# Planning Board Meeting April 25, 2023 – 7:00 PM Town Office Conference Room

RE: Jonathan MacLean, 1505 Maine Street ~ Site Plan Review Application

#### GRAVEL WETLAND #1

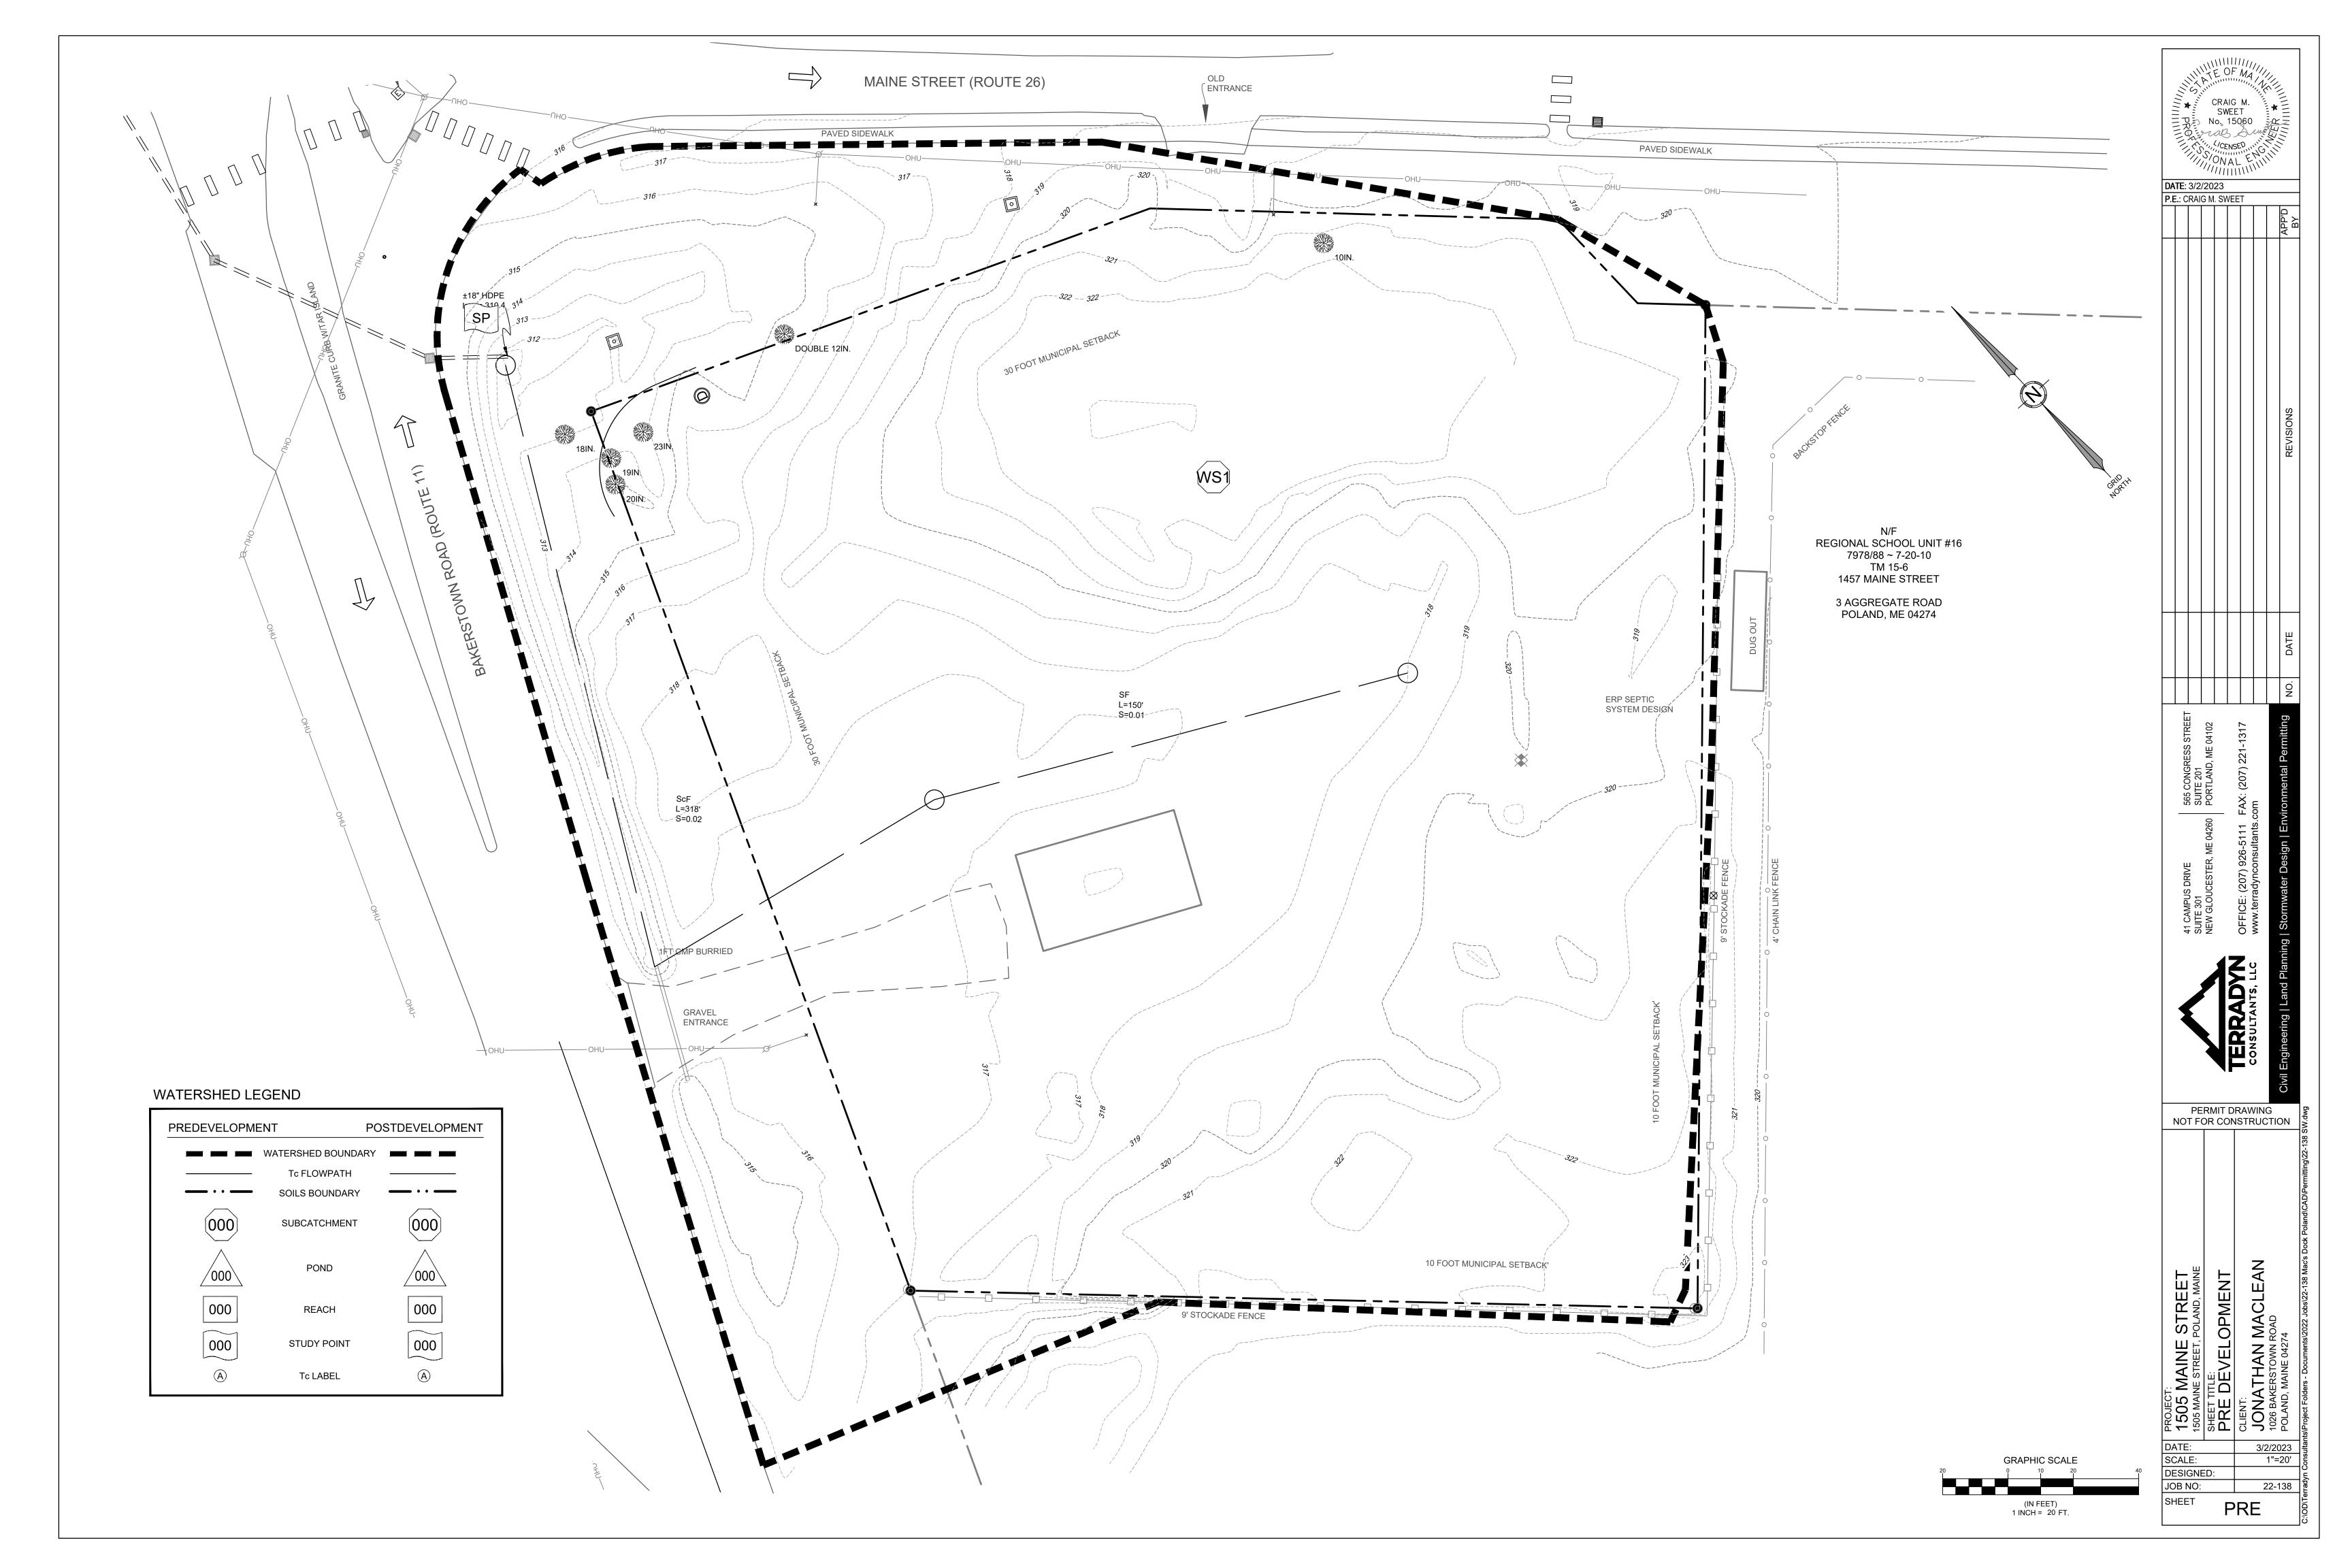
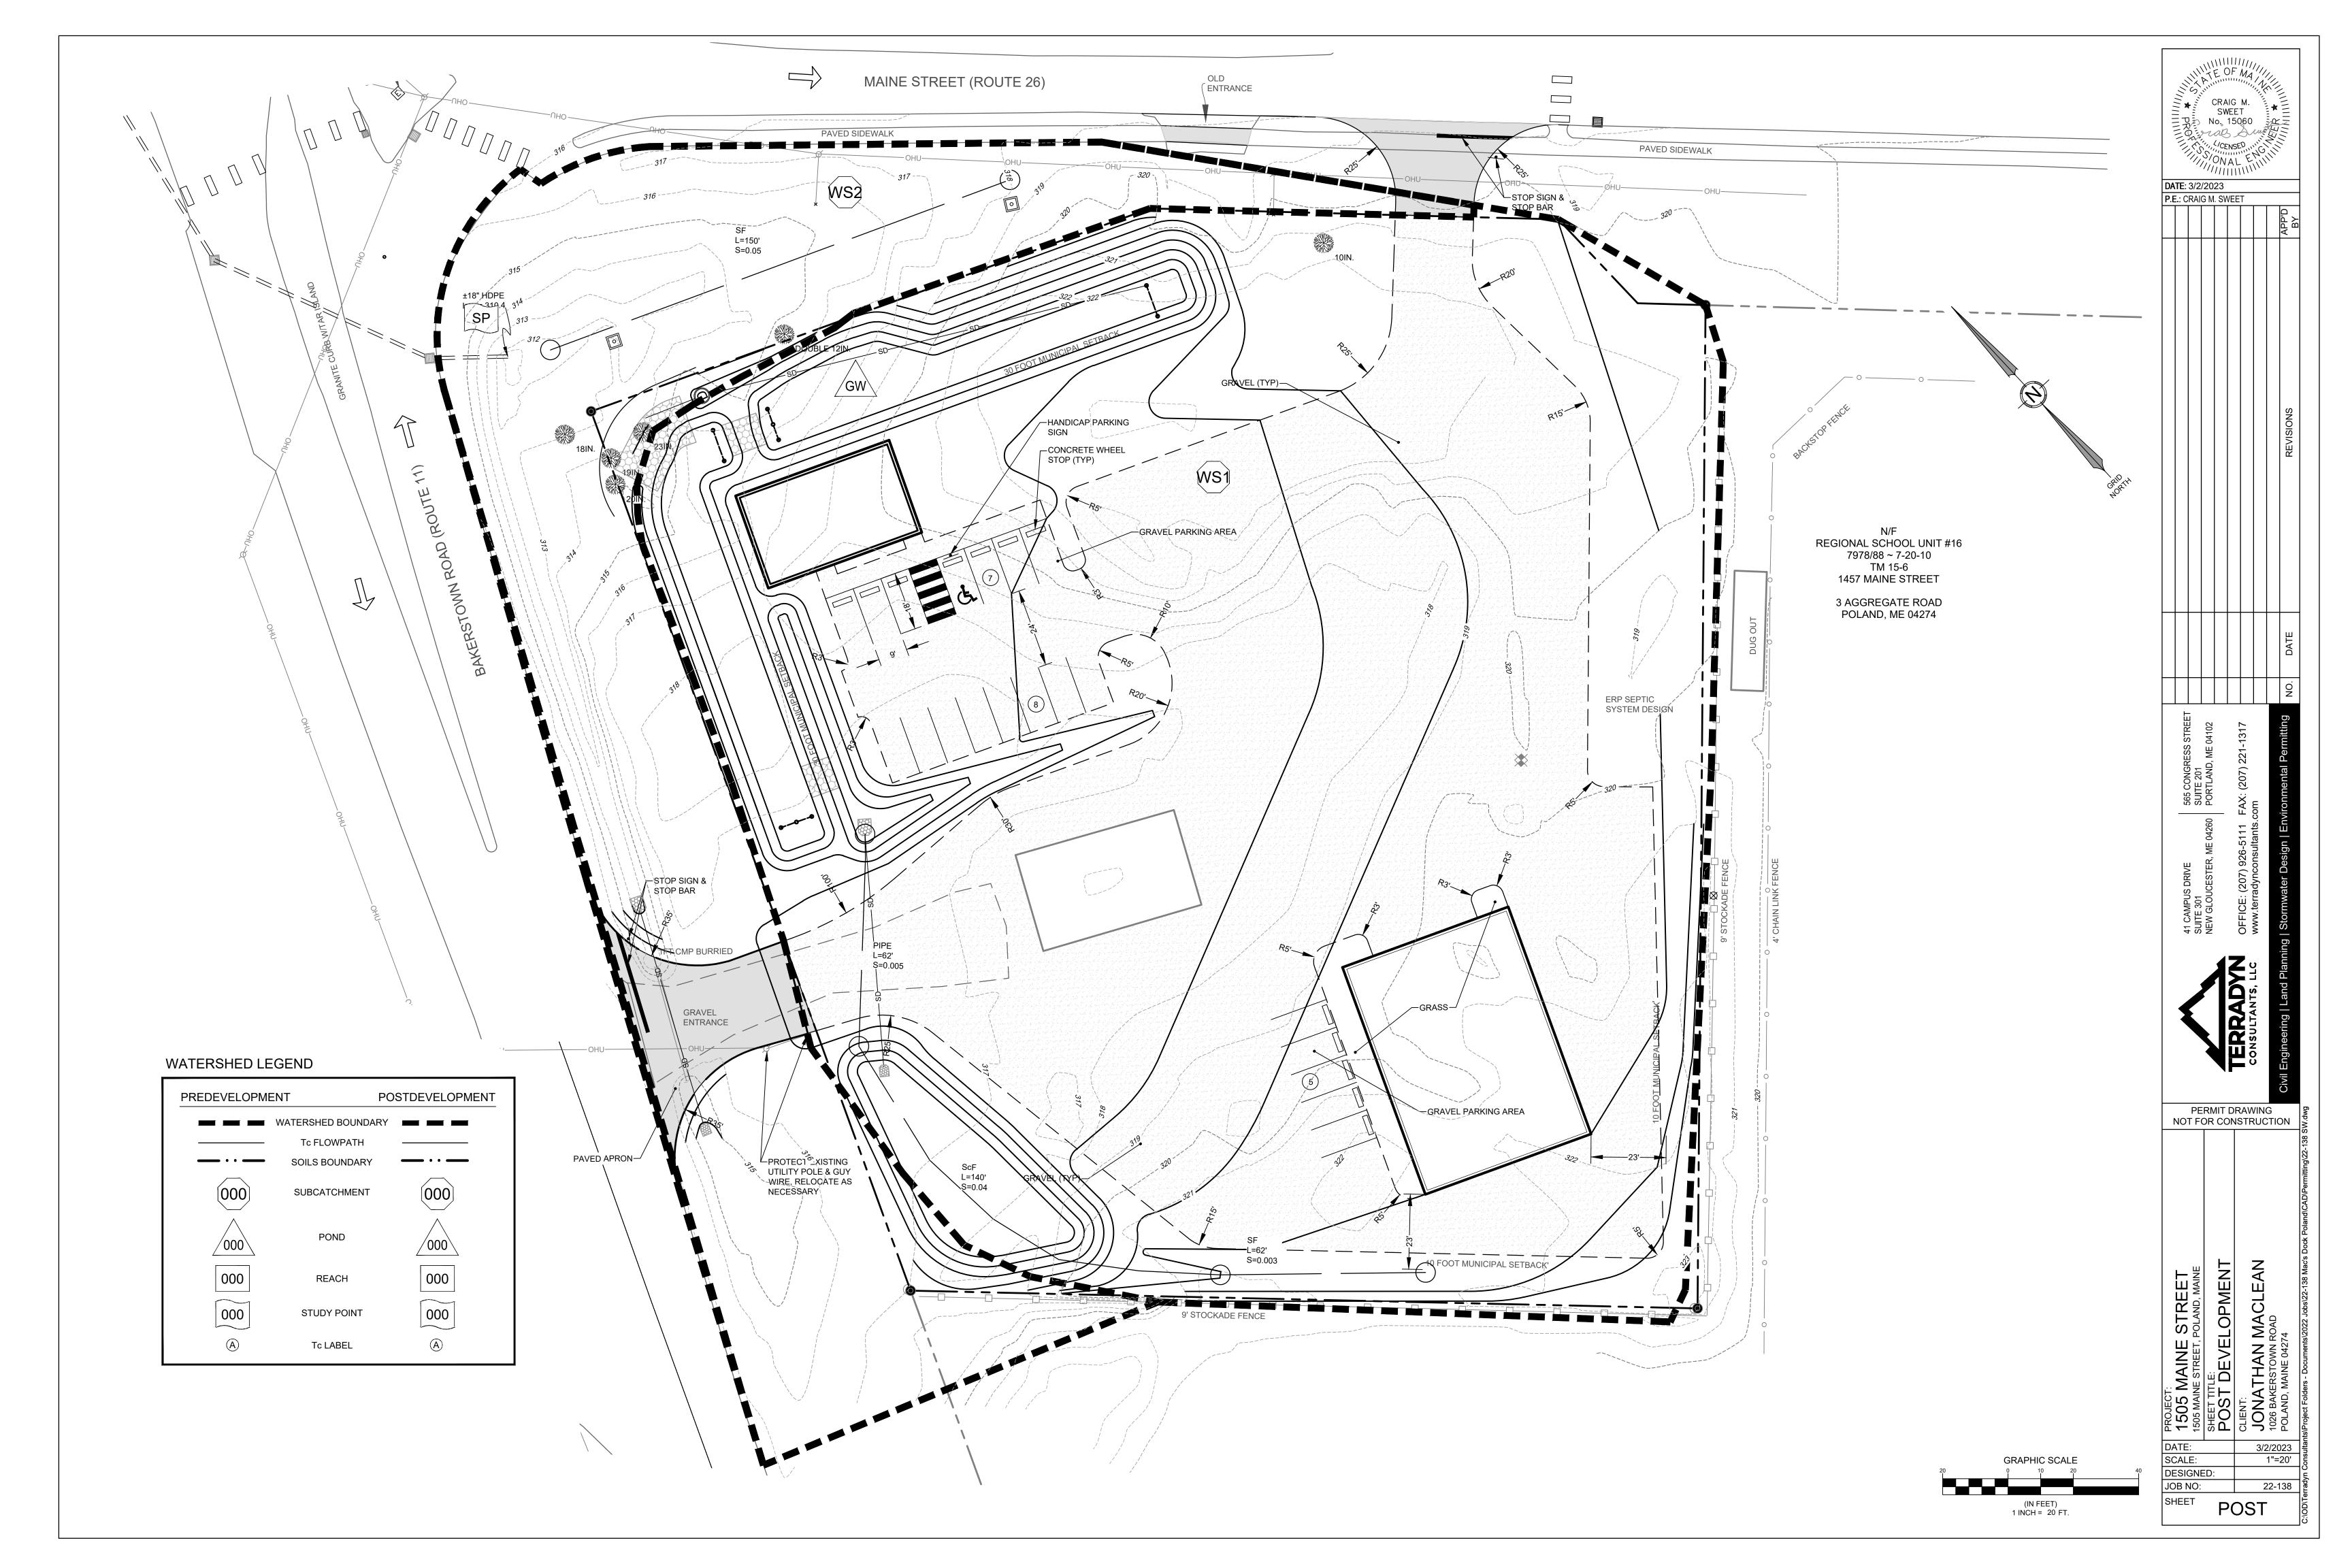
- b. Indicate on sheet C-2.1 gravel wetland cross section the peak elevations in the gravel wetland for the 2-, 10-, and 25- year storm events.
  - c. Include a specification for gravel wetland embankment material.

- e. Unclear if gravel wetland meets target detention time of 24 to 48 hours. Please provide documentation and calculations.
  - f. Post-development HydroCAD model shows emergency spillway elevation of 316.25 (higher embankment crest), sheet C-2.0 notes 315.50, and sheet C-2.1 notes 316.25. Ensure the plans, details, and models reflect the designers' intentions and the project can be constructed.

- g. Post-development model indicates a 15" diameter RCP outlet. Sheets C-2.0 and C-2.1 notes a 12" diameter outlet pipe. Please correct to match designed model.

- h. Callout pressure treated boards on C-2.1 Emergency Spillway Cross Section.
  - i. Review elevations listed on sheet C-2.1 Outlet Control Structure (OCS) detail. Describe inlet, outlet, and weir configuration. Are inlet and outlet on the same side of bulkhead panel? If so, describe purpose of bulkhead. OCS detail notes 1" diameter hole in 6" underdrain cap. Gravel Wetland Cross Section notes a 2" diameter hole. The post-development HydroCAD model indicates a 1" diameter hole. Ensure the plans, details, and models reflect the designers' intentions.

- j. Based on Gravel Wetland Cross Section on sheet C-2.1, the underdrain (UD) is to be placed 6" above the bottom of the <sup>3</sup>/<sub>4</sub>" crushed stone. The total gravel wetland section is 50" and BMP floor is elevation 314. This results in a UD invert of 310.33. The post-development HydroCAD model indicates 311.75. Ensure the plans, details, and models reflect the designers' intentions.
- k. Indicate wetland species plantings and locations on a Landscaping Plan.
- 4. The applicant shall provide the Town with evidence of an executed maintenance agreement for the BMPs.
- 5. Pre- and post-development HydroCAD models contain Type II rainfall distributions. Chapter 500 Appendix H lists a Type III distribution for Androscoggin County. Please verify the correct rainfall distribution selection that is to be used per Maine DEP requirements.
